Service Bulletin

SB No.: SB-053 Iss1	CCAR No.:	Classification:
Aircraft type & model (applicability) MT-03 MTOsport Calidus	Aircraft serial Nos. affected See comments below and refer to Appendix 1 for list of aircraft serial numbers affected.	OPTIONAL or RECOMMENDED or MANDATORY

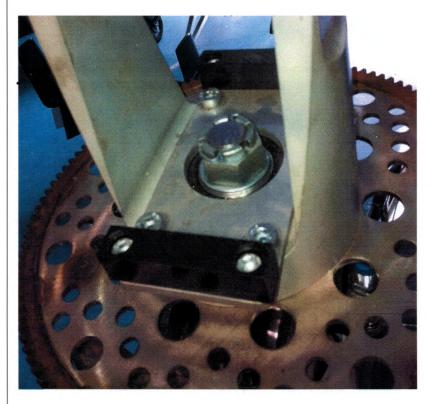
- 1. Place a 30mmAF ring spanner on the hex-head bolt on the underside of the rotor-head. Clamp this ring spanner in a substantial vice as shown in the photo above. Note the orientation of the bolt head.
